COMMITTEE OF THE WHOLE OCTOBER 24, 2005

SITE DEVELOPMENT FILE DA.02.080
KHMER BUDDHIST TEMPLE OF ONTARIO

Site Plan

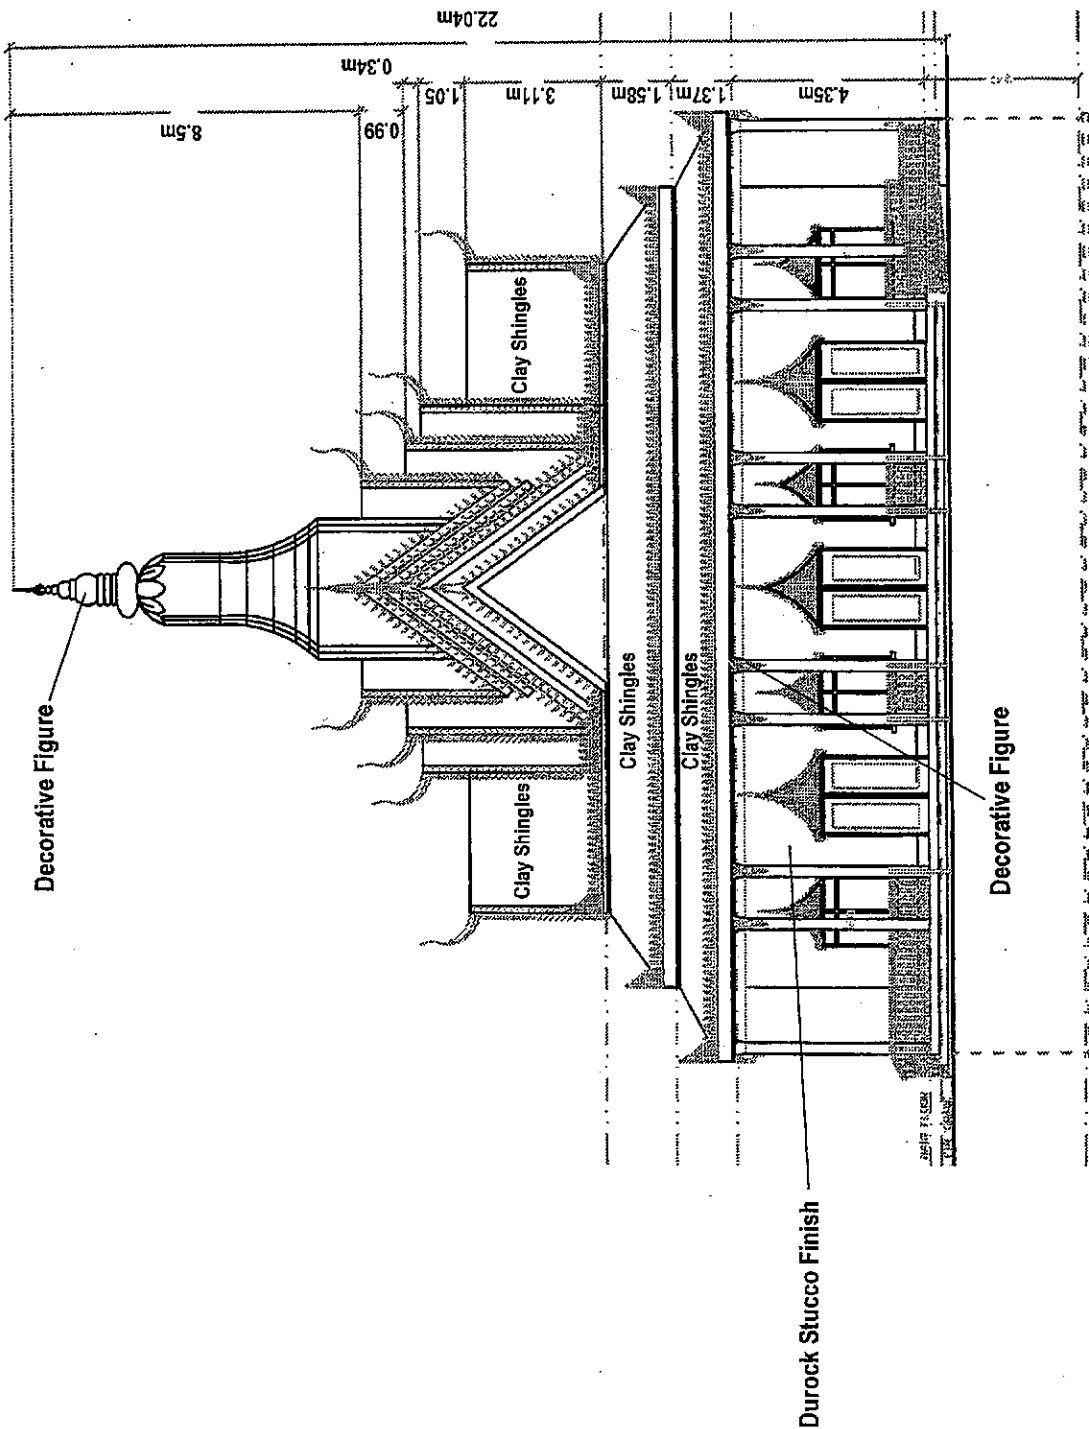
The proposed site plan shown on Attachment #2 consists of the existing building that is centrally located on the property with a 542.5m² addition proposed between the existing building and Keele Street, and represents an expansion of the existing place of worship. The proposed addition is linked to the existing building via an enclosed building connection. A walkway is proposed around the perimeter of the addition and extends along the north limit of the parking lot.

A parking area with 62 parking spaces is proposed in the rear yard, which is accessed by a vehicular driveway located along the north property line. An additional three parking spaces are provided in the garage attached to the existing building.

- additional buffer plantings are required adjacent to the northern, northeastern and eastern limits of the property;
- the stormceptor should be placed downstream of the proposed control manhole;
- additional details regarding the storm sewer outfall are required;
- changes to the proposed swale should be reviewed in order to enhance the water quality control and an overall net environmental benefit; and,
- a permit pursuant to Ontario Regulation 158 is required for the proposed development.

The Region of York Transportation and Works Department has reviewed the proposed site plan and has provided red-lined comments respecting the driveway access design, to the applicant, and the final site plan must be to their satisfaction.

THAT Site Development File DA.02.080 (Khmer Buddhist Temple of Ontario) BE APPROVED, subject to the following conditions:

1. That prior to the execution of the site plan agreement:
 - a) the final site plan, building elevations, and landscape plan shall be approved by the Development Planning Department;

- b) the final site servicing, grading and stormwater management plans shall be approved by the Engineering Department;
 - c) the final landscape plan shall address the requirements of the Village of Maple Streetscape Master Landscape Plan and Design Study to the satisfaction of the Development Planning Department;
